CITY OF NOVI CITY COUNCIL
FEBRUARY 23, 2026

SUBJECT: Consideration for tentative approval of the request of Avalon Investment Group, LLC, JSP25-02 Camelot Parc Townhomes, for a Planned Suburban Low-Rise (PSLR) Overlay Development Agreement Application and Concept Plan.

SUBMITTING DEPARTMENT: Community Development Department - Planning

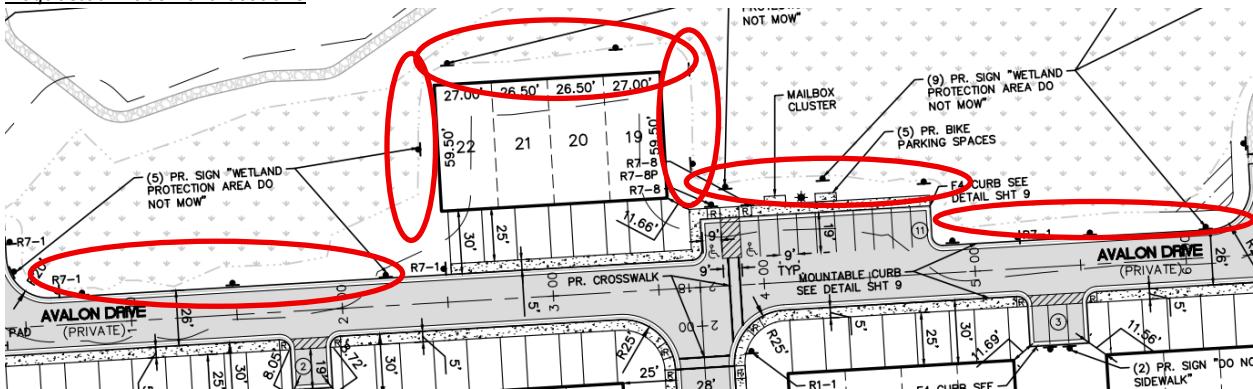
Requested edit: In future submittals, buffer impacts should be differentiated by permanent and temporary impacts (if applicable). If impacts are temporary, descriptions or sequencing should be provided showing how the temporary impacts will be restored. The temporary wetland restoration sequencing provided on Sheet 7 can be applied to any temporary buffer impacts – the header will need to be updated. Identify any temporary buffer impacts using a different symbology in the site plan.

Requested Placement locations

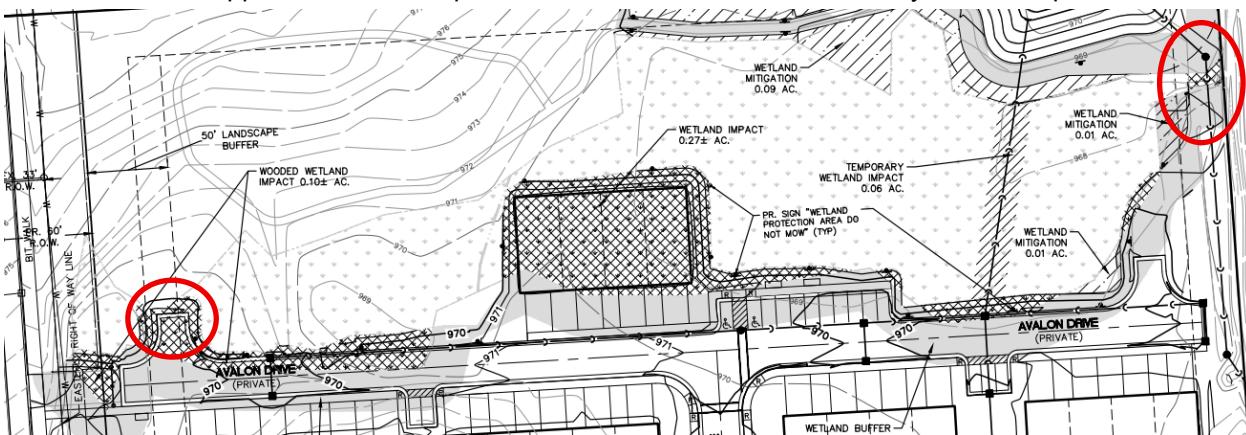
Due to the extensive proposed loss of wetland buffer along the southern remaining wetland area, it is requested that the applicant perform environmental enhancement along the southern portion of the remaining wetland (see screenshot below). The applicant should plant at least three different species of wetland rated shrubs throughout the southern boundary of the wetland. This will allow a small separation from the wetland and the proposed development. Additionally, it will deter any accidental mowing of the wetlands and remaining buffer areas. Shrubs could include three of the following species:

Figure 2. City of Novi Regulated Wetlands Map

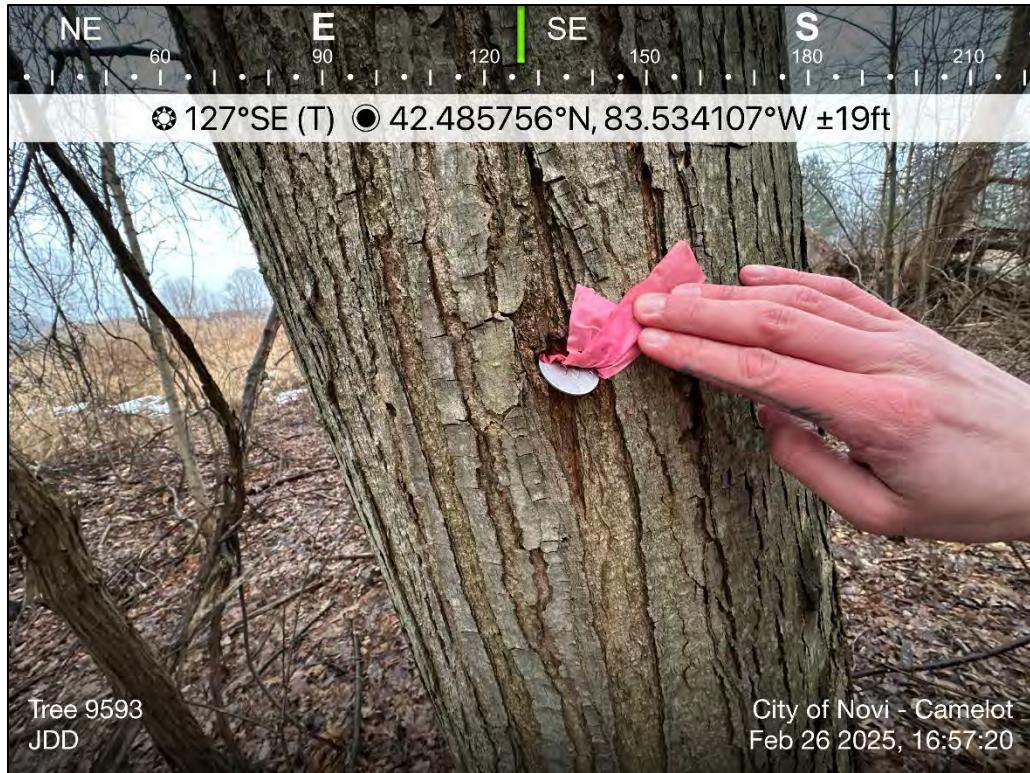
- City-regulated wetlands, as identified on the City of Novi interactive map website. Note that both wetland and property limits depicted on the City's map are considered approximations (**Figure 2**).
- Wetlands that are regulated by the Michigan Department of Environment, Great Lakes, and Energy (EGLE).
- Wetlands as identified on National Wetland Inventory (NWI) and Michigan Resource Inventory System (MIRIS) maps, as identified on the EGLE Wetlands Viewer interactive map website (provided in previous review). NWI and MIRIS wetlands are identified by the associated governmental bodies' interpretation of topographic data and aerial photographs.

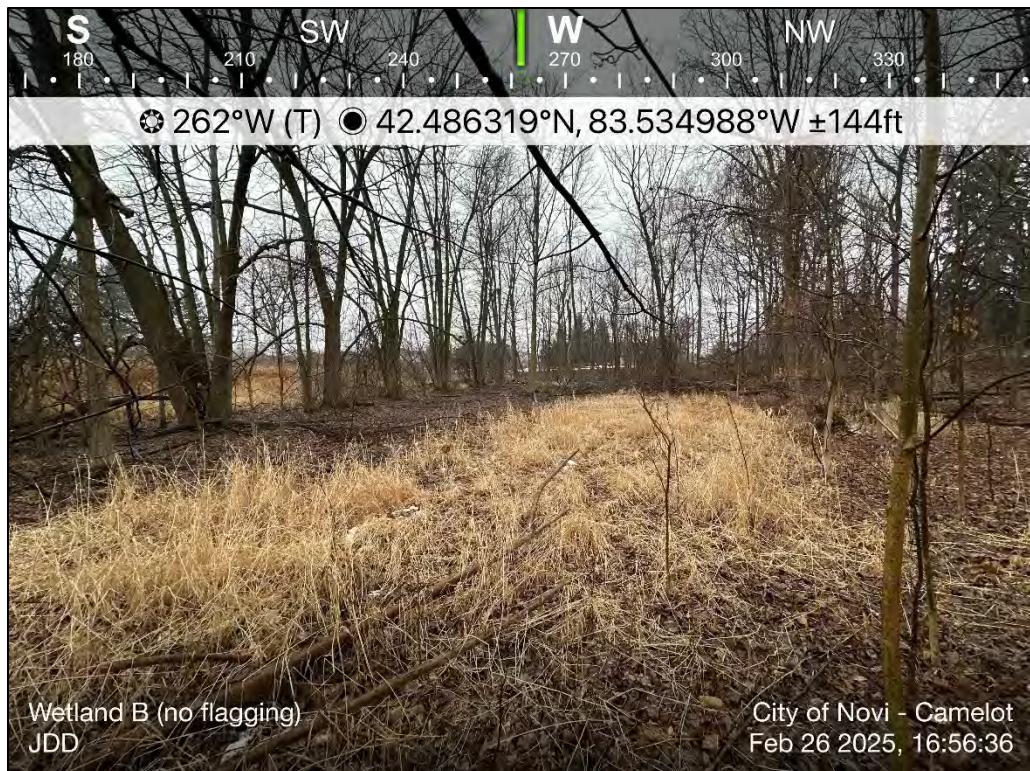
A potential unmarked wetland at the southern edge of the site in a concave swale with *Populus deltoides* saplings, *Phalaris arundinacea* dominant herbaceous cover, and standing water.

A potential unmarked wetland at the southern edge of the site in a concave swale with *Populus deltoides* saplings, *Phalaris arundinacea* dominant herbaceous cover, and standing water.

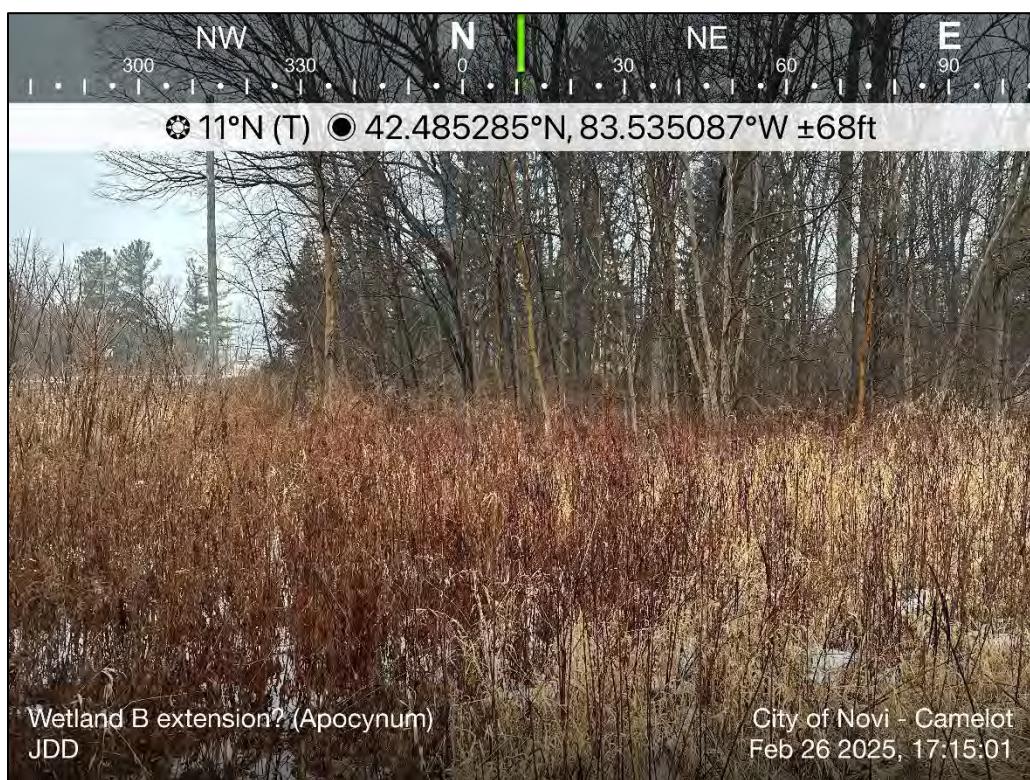
Wetland B may have expanded over the past 4-5 years. The southwest boundary is dominated by a mix of *Phalaris arundinacea* and *Apocynum cannabinum*.
